ORIGINATION FORM

Proposed Revisions to a Standard Plans Index (Please provide all information — Incomplete forms will be returned)

Index Number: 700-040
Sheet Number (s): 2 of 5
Index Title: Cantilever Sign Structure

FRONT ELEVATION
FOOTING AND PEDESTAL

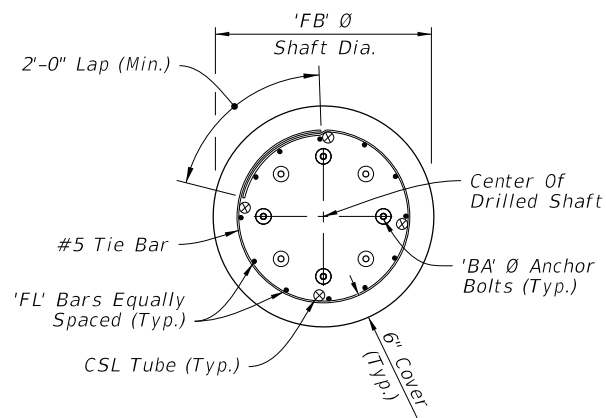
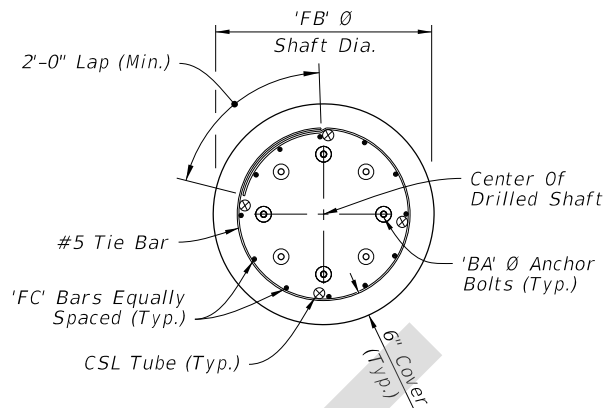
Sheet 2: Changed the 2'-2" lap splice for the #5 tie bars on the spread footing plan view to 1'-8"; Revised Note 5 to read "After galvanizing, provide magnetic particle testing on 100% of upright fillet welds."

The reference shown for longitudinal bars is incorrect.

Required lap length for #5 tie bars for spread footing shall be shorter rather than longer than what is required for drilled shaft (2'-0") due to higher concrete strength of spread footing.

FOUNDATION BASE PLATE CONNECTION

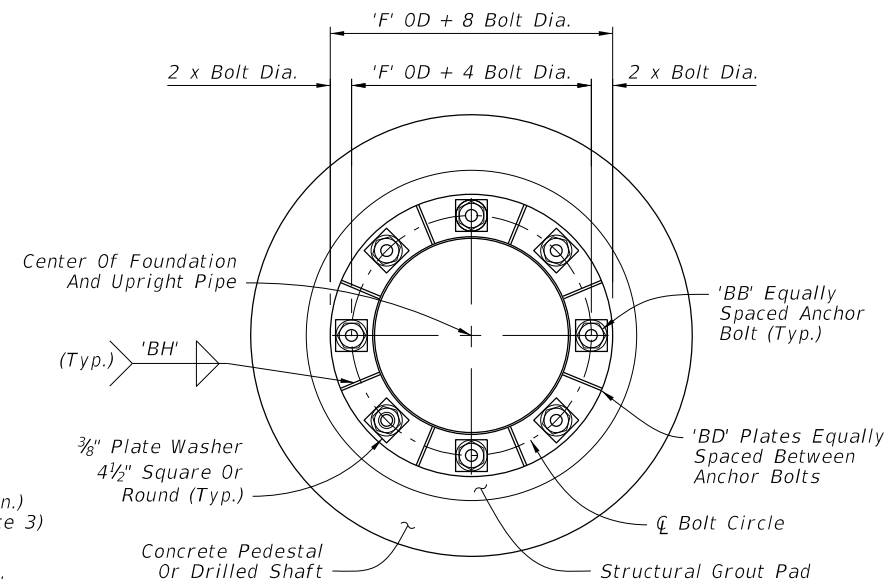
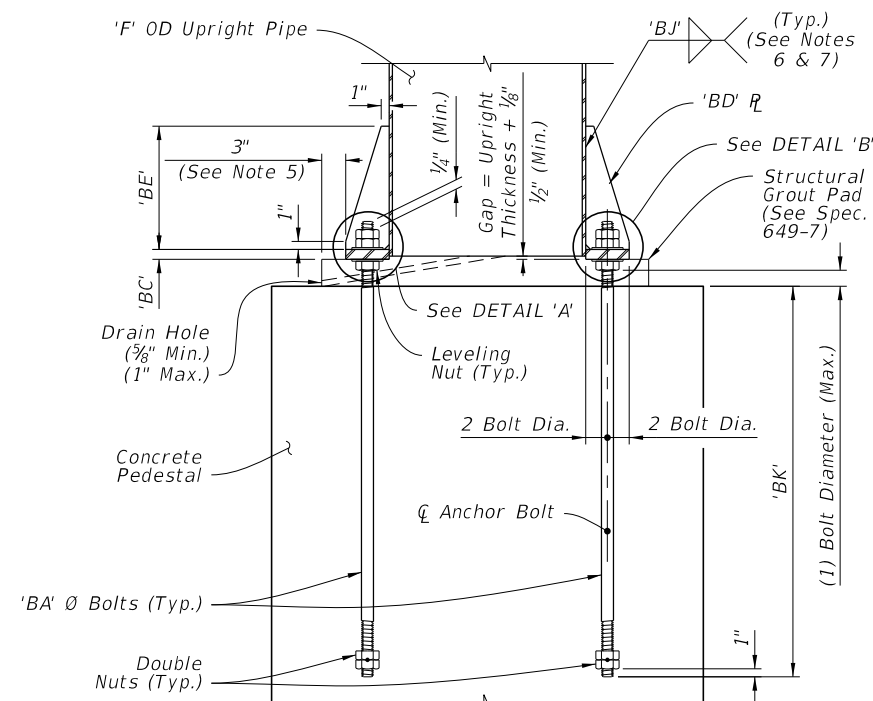
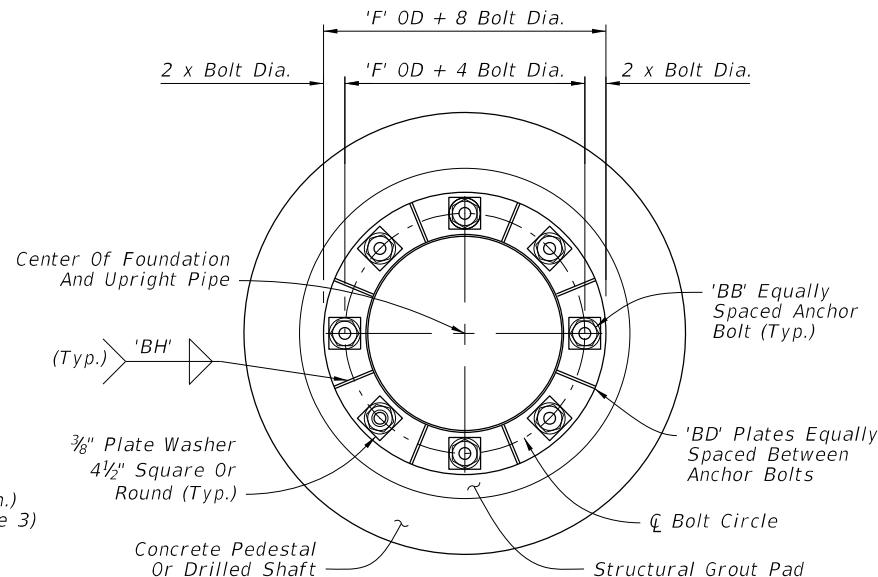
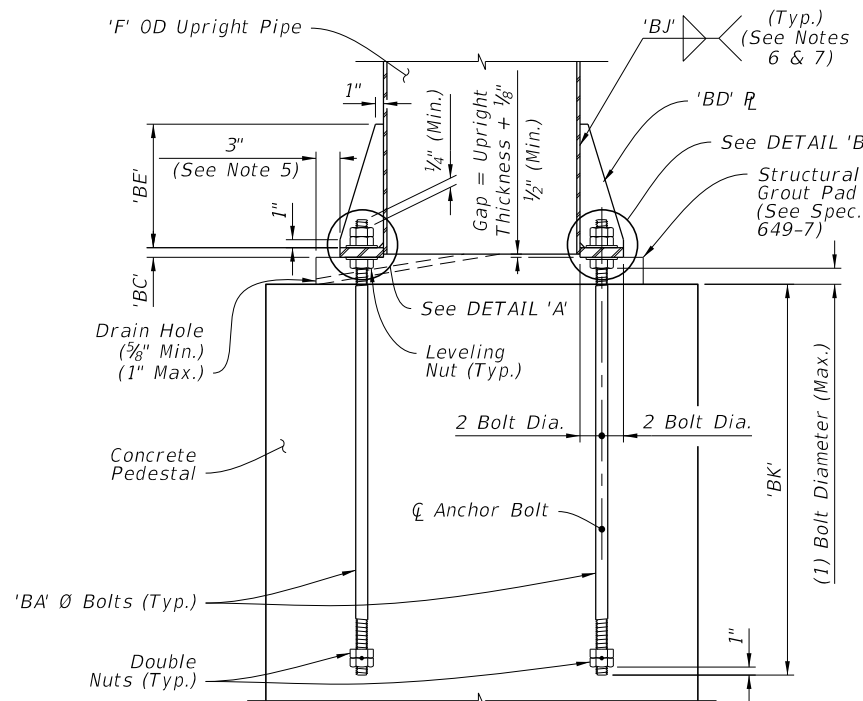
Additional Commentary: During maintenance inspections, weld cracks were found on in-service overhead sign structure supports. A FDOT investigation determined the cracks were formed during fabrication. To implement a better fabrication quality control processes, the note on the Standard is being changed.

After galvanizing, provide magnetic particle testing on 100% of upright fillet welds.
